National Transportation Safety Board

Safety Recommendation

In reply refer to: A-98-112

Figure 1. Piper PA-31 Main Landing Gear Door Assembly

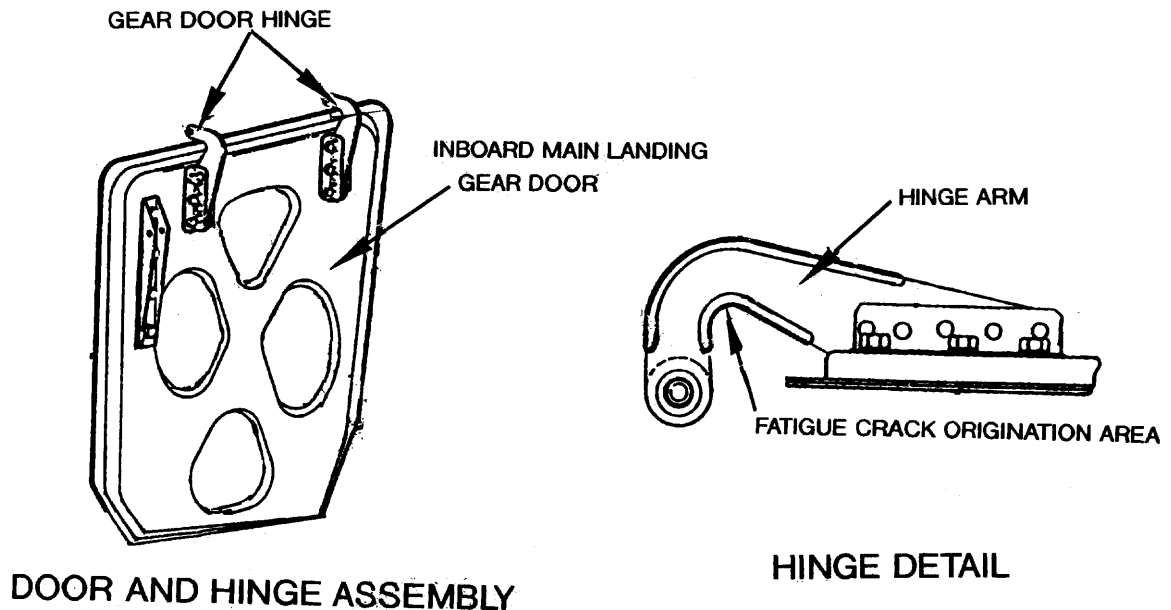
The National Transportation Safety Board's materials laboratory examined the fracture surfaces of the broken hinge. The examination revealed a fatigue crack that had emanated from multiple origins at the tip of the forged flash¹ on the inside curve portion of the hinge arm (see

figure 1). The arm is subjected to cyclic loading during service, and the forging flash is a high-stress region of the hinge.

The Safety Board is concerned that the improved P/N 47529-32, PA-31 MLG inboard door hinge assemblies are failing and that no requirement exists for their recurrent inspection. Piper has indicated its intent to design a new sheet-metal hinge assembly that will replace the P/N

Require Piper PA-31 operators to conduct repetitive inspections for cracks of all Piper part number 47529-32 main landing gear (MLG) inboard door hinge assemblies until they are replaced by an improved MLG inboard door hinge assembly that is not prone to similar failures. (A-98-112)
